# HISTORIC AND DESIGN REVIEW COMMISSION

**HDRC CASE NO:** 2018-132  
**ADDRESS:** 206 W LULLWOOD AVE  
**LEGAL DESCRIPTION:** NCB 6533 BLK 13 LOT 25, AND 26  
**ZONING:** R-5 H  
**CITY COUNCIL DIST.:** 1  
**DISTRICT:** Monte Vista Historic District  
**APPLICANT:** Paul Casseb, Jr., AIA  
**OWNER:** The Dennis P & Jane A Lindsey Living Trust  
**TYPE OF WORK:** Construction of a 2-story single family structure and 2-story rear accessory structure, modifications to an existing wall  
**APPLICATION RECEIVED:** March 16, 2018  
**60-DAY REVIEW:** May 15, 2018  
**REQUEST:**

The applicant is requesting conceptual approval to construct a two-story residential structure and a two-story rear accessory structure on the vacant lot at 206 W Lullwood. The proposal also includes hardscaping, landscaping, and modifications to an existing stone wall.

SOUTH (REAR) ELEVATION COLOR SCHEME #1

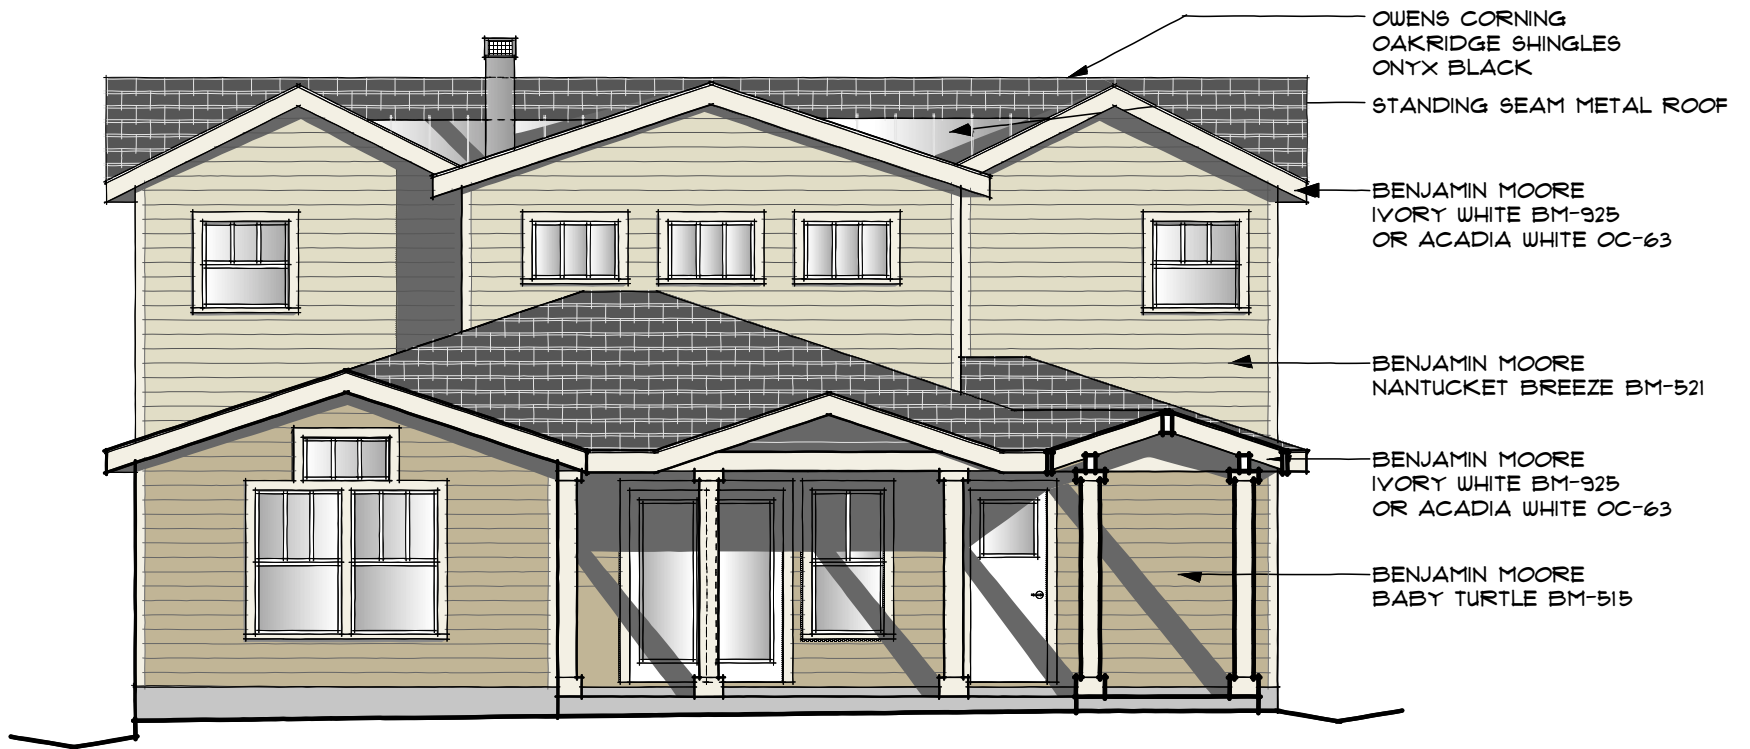
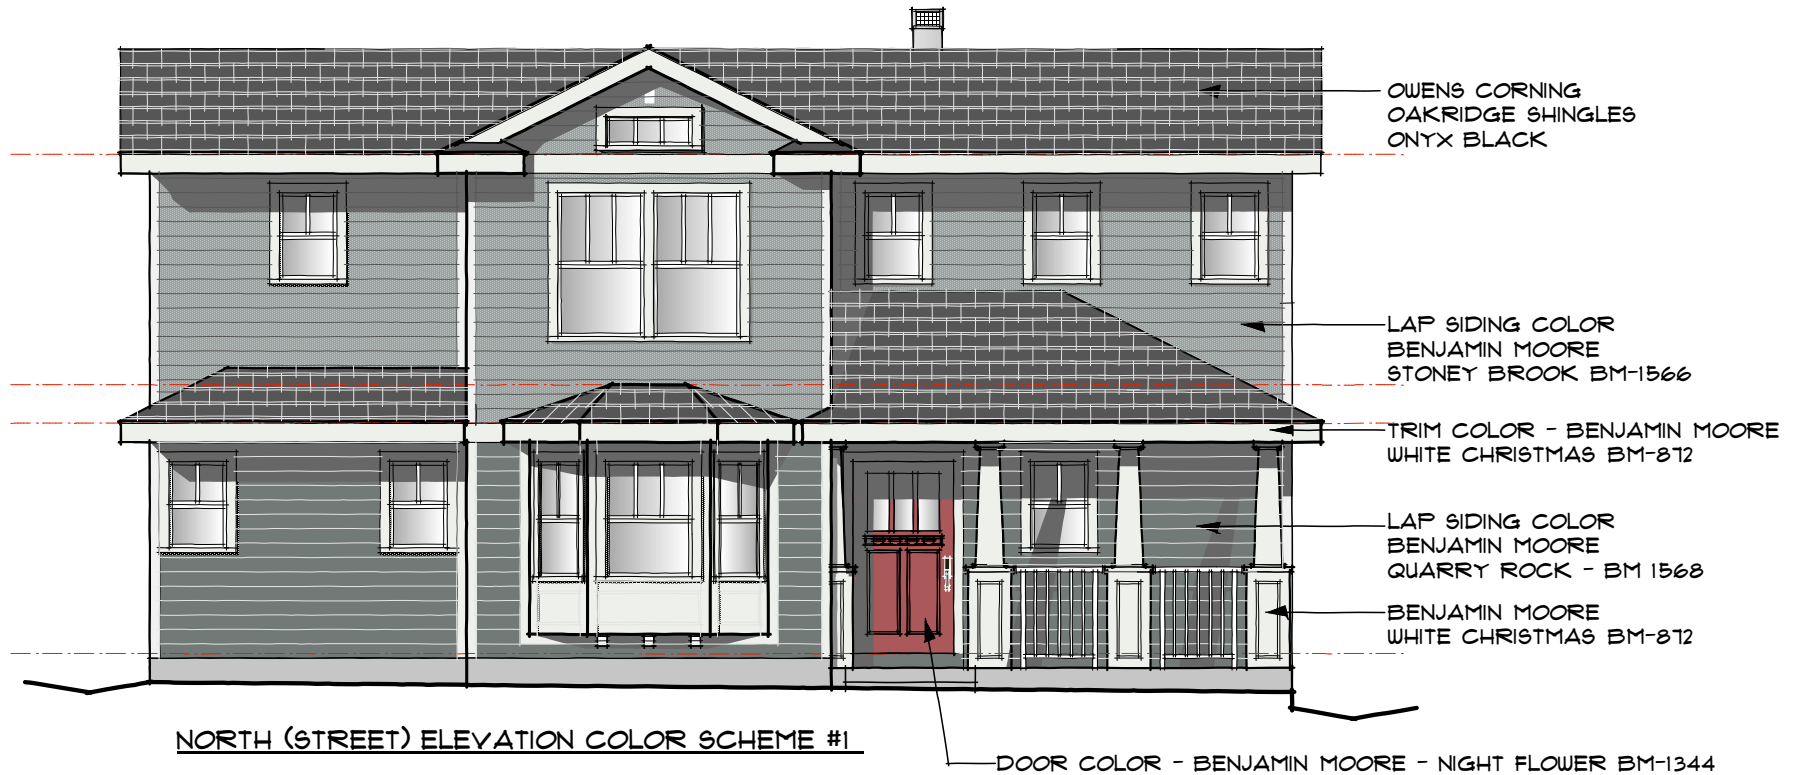
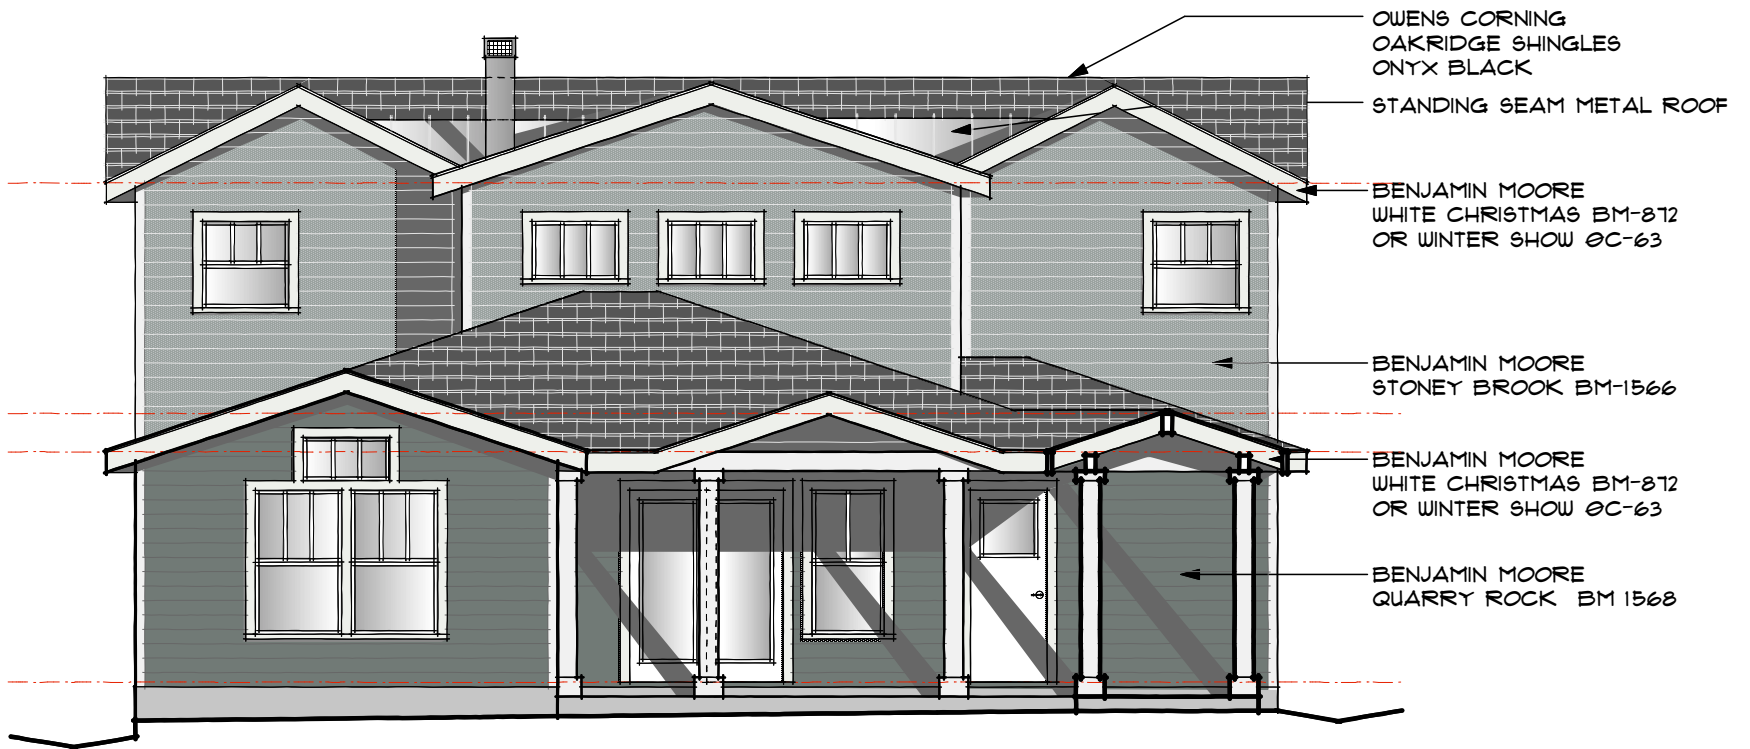
||: Simplify roof in the back.

~~AMG~~: DL: Front elevation doesn't look too cluttered, but rear is complex.

MG: RELATIVE COMPLEXITY OF FRONT FACADE  
DIFFERS FROM WHAT YOU'D SEE ON BLOCK. MORE  
SIMPLICITY. REAR FACADE ALSO BUSY →

CONCERN IS VIEW; REAR ELEVATION WON'T BE SEEN.
